Access Compliance Report

Public Rights-of-Way

(Curb Ramps)

Intersection ID: 6522	Main Street: DEDMON_DR	Cross Street: FIRESTONE_DR	Location:	W
ADA ID: 999C16185E91	Ramp Type: Perp	Initial Pass/Fail: Fail	Overall Compliance: No	Severity Score: 1.25
Codes/Mitigation Info/Possible Solution		Field Measurements/Component Compliance

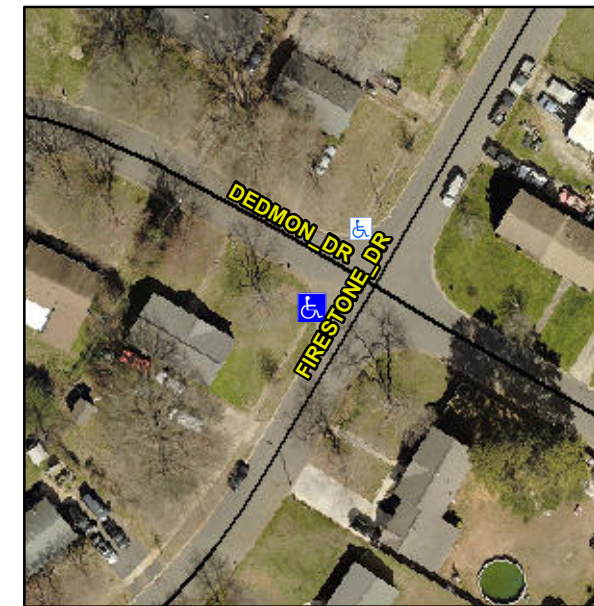
Not Found, R304.5.3

Compliance	Description	Data	Compliance	Description	Data
N/A	Ramp Length (in)	26.5	Yes	Ramp Slope (%)	5.5
Yes	Ramp Width (in)	54.0	No	Ramp XSlope (%)	2.5
N/A	Flare Type LT	N/A	N/A	Flare Type RT	N/A
N/A	Flare Slope LT (%)	N/A	N/A	Flare Slope RT (%)	N/A
N/A	Flare Traversable LT?	N/A	N/A	Flare Traversable RT?	N/A
N/A	Landing Length (in)	N/A	N/A	DWS Provided?	N/A
N/A	Landing Width (in)	N/A	N/A	DWS Contrast?	N/A
N/A	Landing Slope (%)	N/A	N/A	DWS Length (in)	N/A
N/A	Landing X Slope (%)	N/A	N/A	DWS Full Width?	N/A
N/A	Landing Curb? (Y/N)	N/A	N/A	DWS Offset (in)	N/A
N/A	Shared Landing?	N/A			
N/A	Gutter Ponding?	N/A	N/A	Gutter Slope (%)	N/A
N/A	Gutter Lip Ht (in)	N/A	N/A	Gutter X Slope (%)	N/A
N/A	Painted X Walk1?	No	N/A	Painted X Walk2?	N/A
	X Walk 1 Direction	To NE		X Walk 2 Direction	N/A
N/A	X Walk 1 Width (in)	N/A	N/A	X Walk 2 Width (in)	N/A
	X Walk 1 Slope (%)	2.5		X Walk 2 Slope (%)	N/A
	X Walk 1 X Slope (%)	1.5		X Walk 2 X Slope (%)	N/A

Remove & Replace Entire Ramp.
